THE CITY OF WALTHAM
MASSACHUSETTS

ADA Bathroom Adaptation, 2020

ADDENDUM NO. 3

July 10, 2020

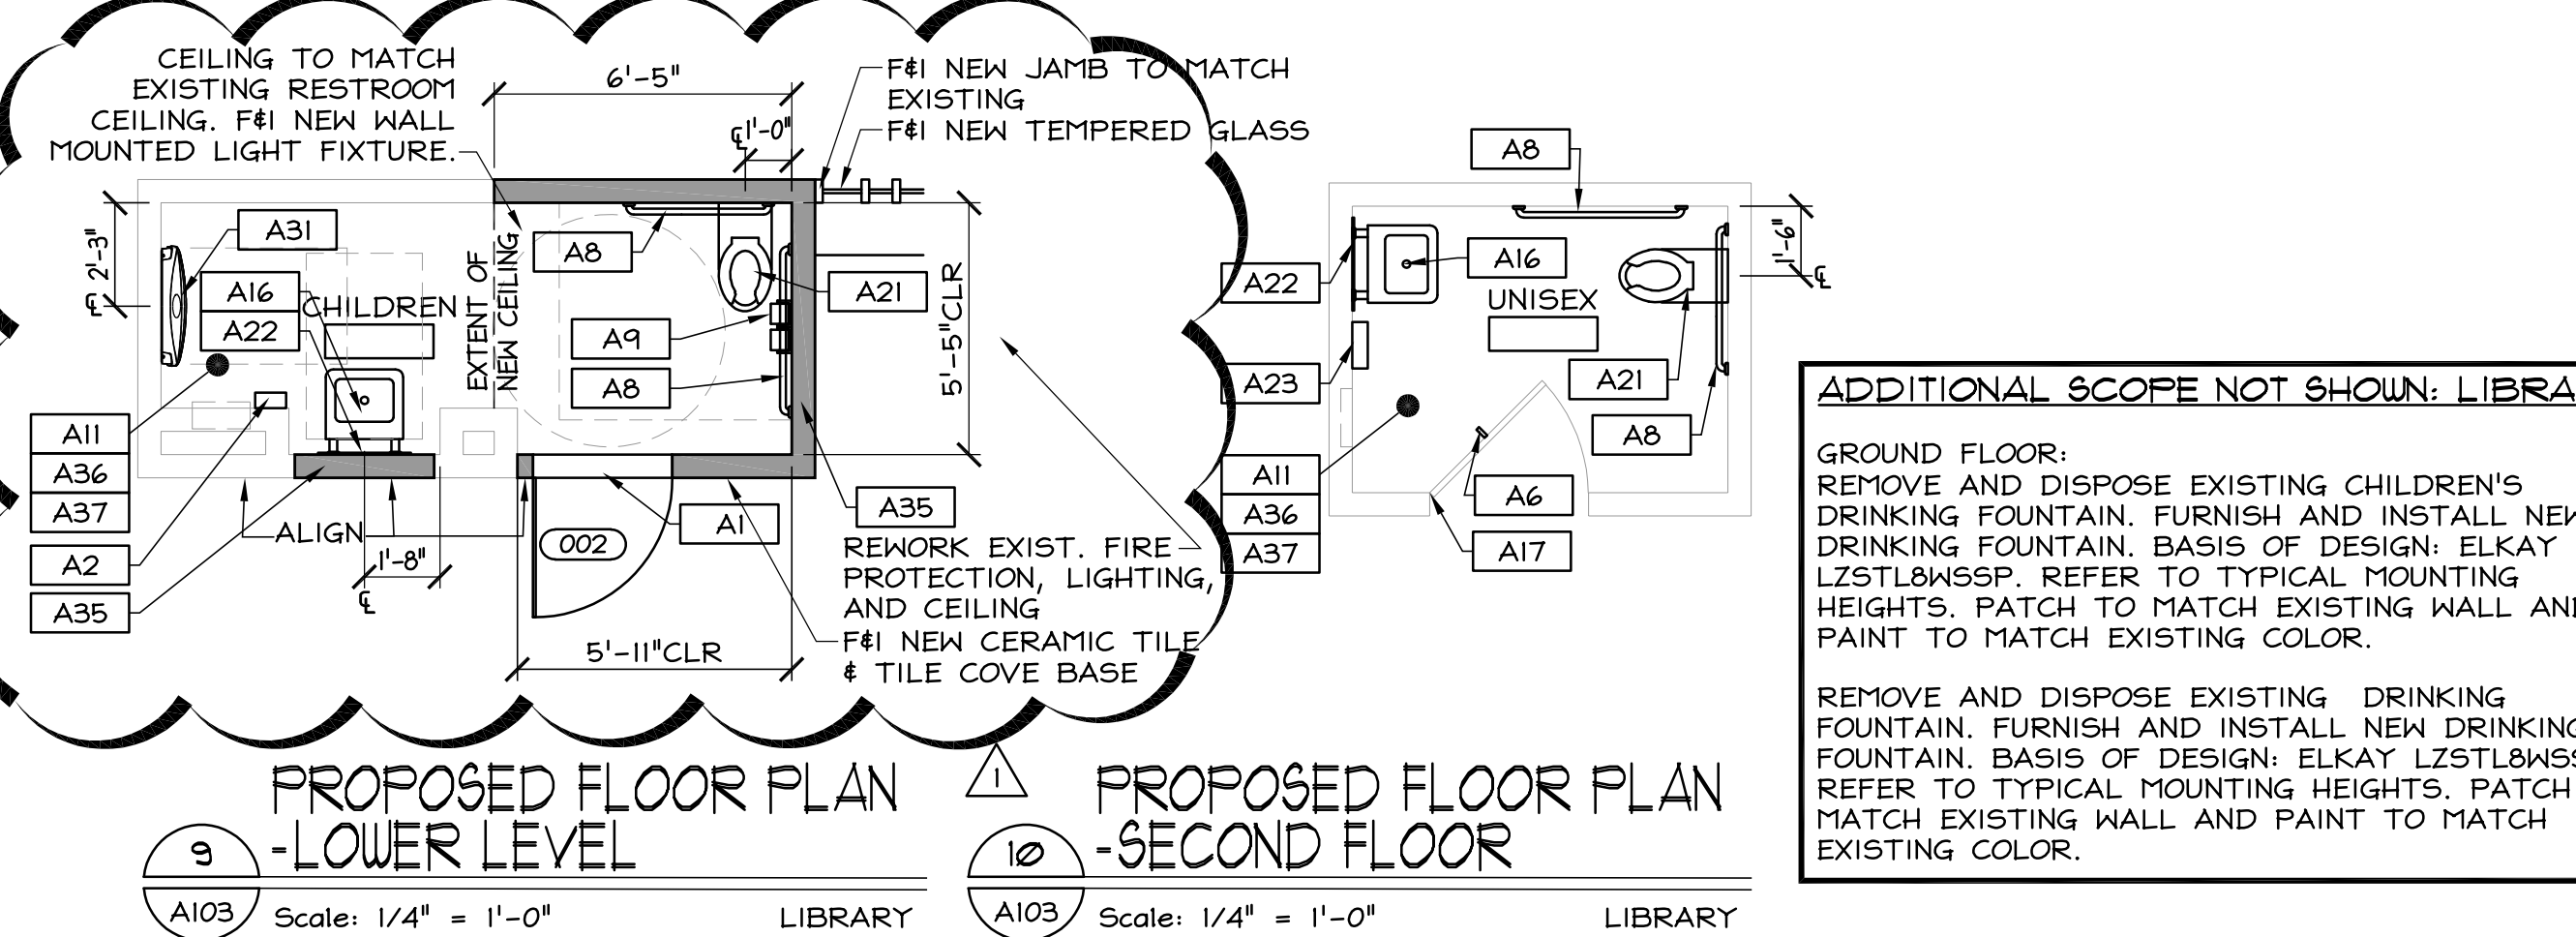
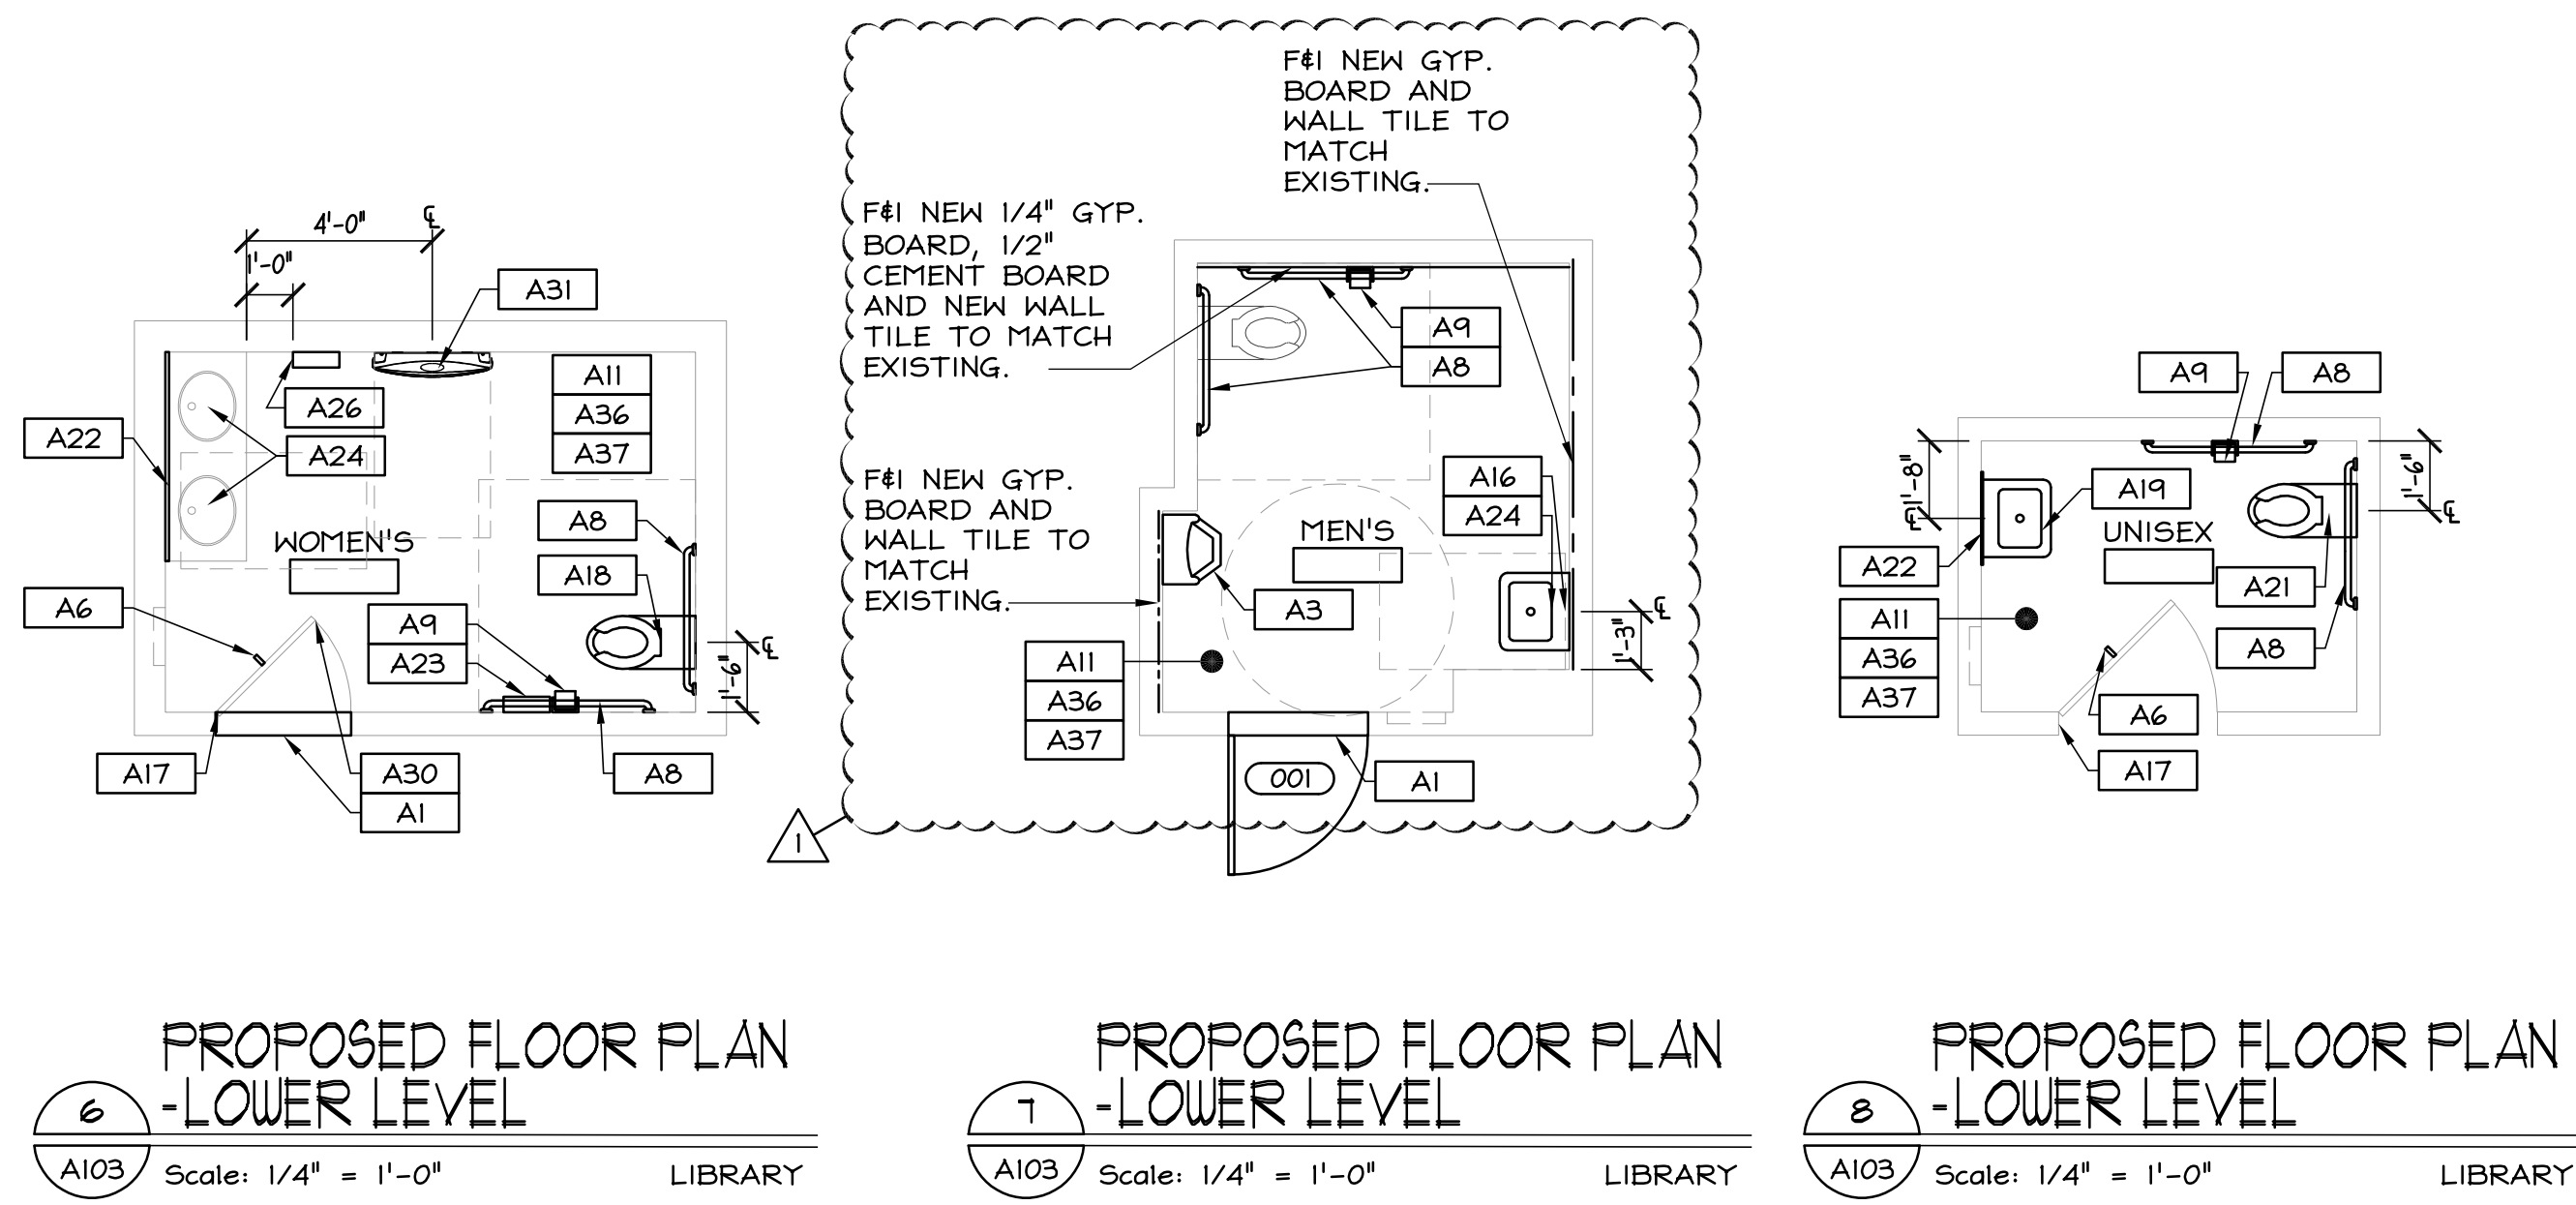
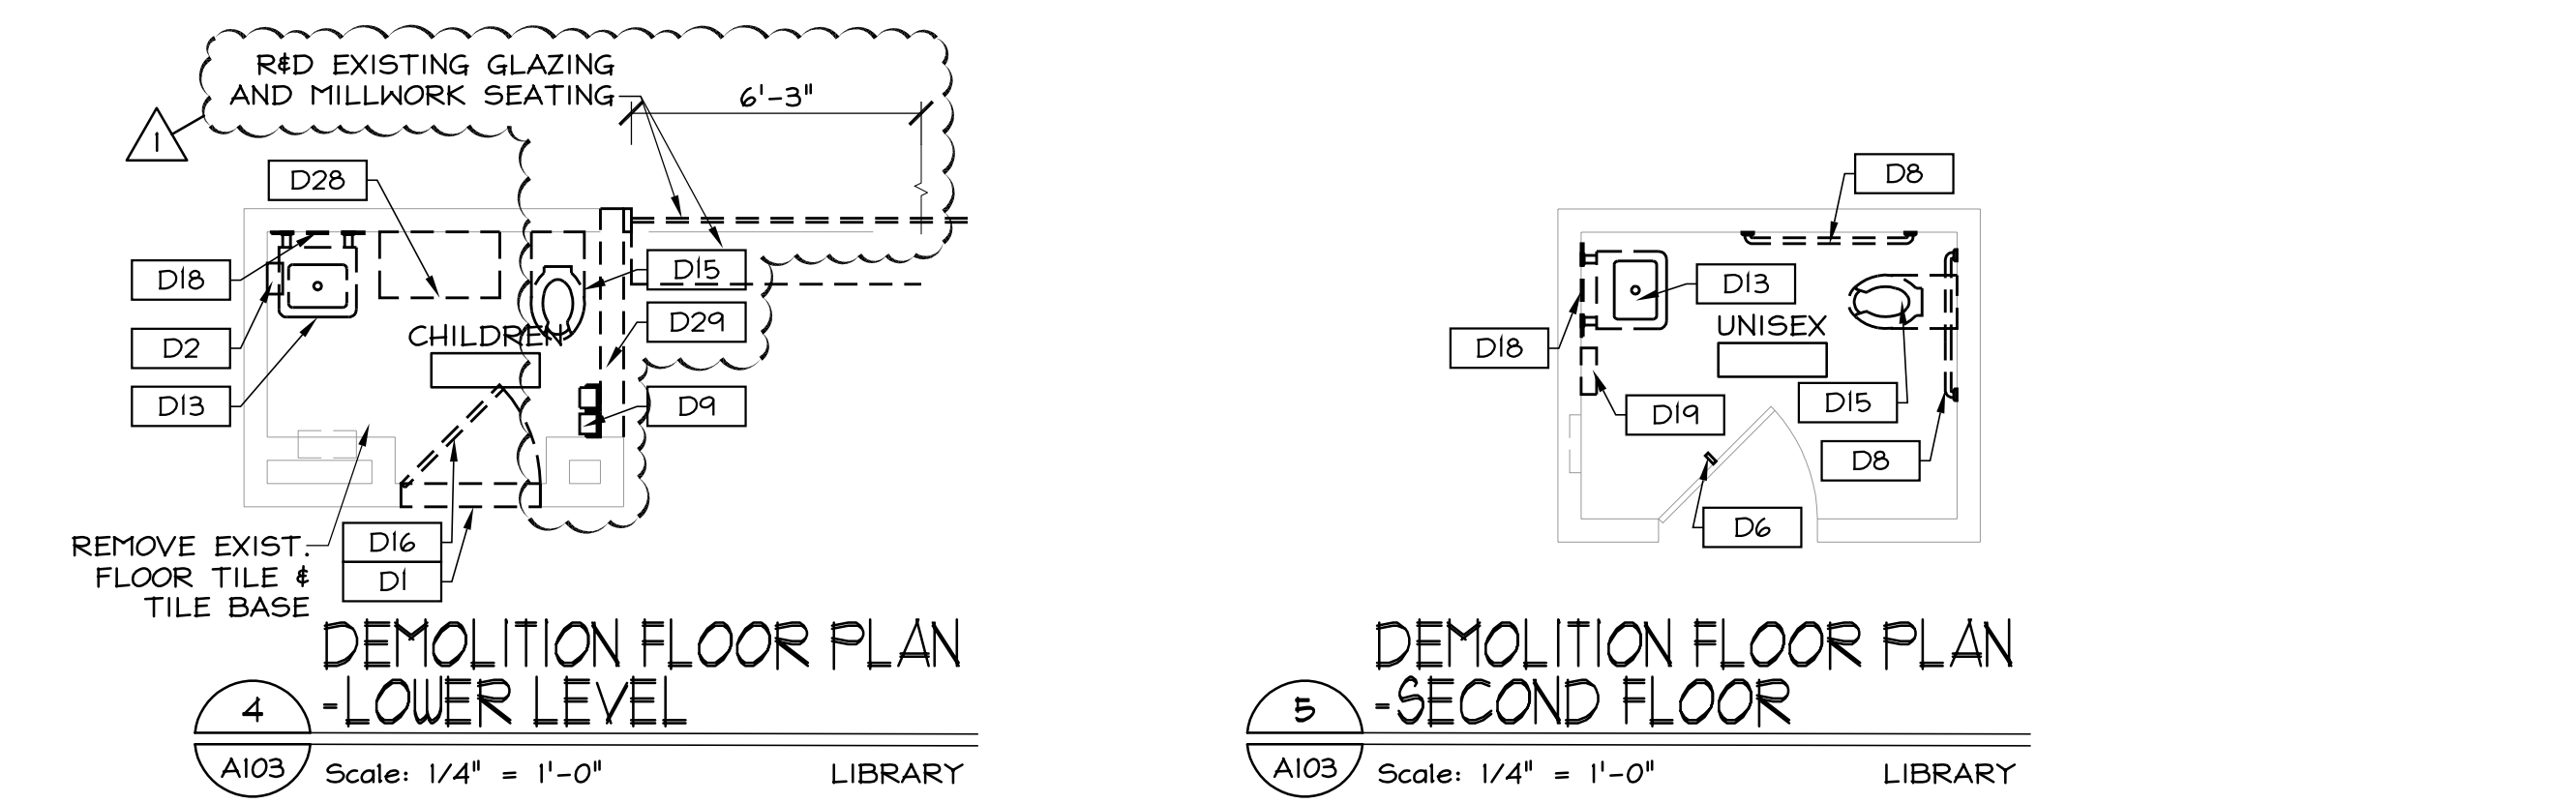
Q4. Plan A103, children's bathroom shows a chase on the demo plan. During the walk-through it is to believe there is a structural post supporting the large beam above the ceiling. Please advise

Q5. Plan A103, children's bathroom shows the wall to be extended out, there is a sprinkler head and light fixture that will need to be relocated. Please advise

Q6. Plan A103, will any additional lighting be added to children's bathroom?

If the tile color cannot be matched exactly, is a similar color acceptable or will the entire wall need to re-tiled?

A4. See attached drawings

A5. See attached drawings

A6. See attached drawings
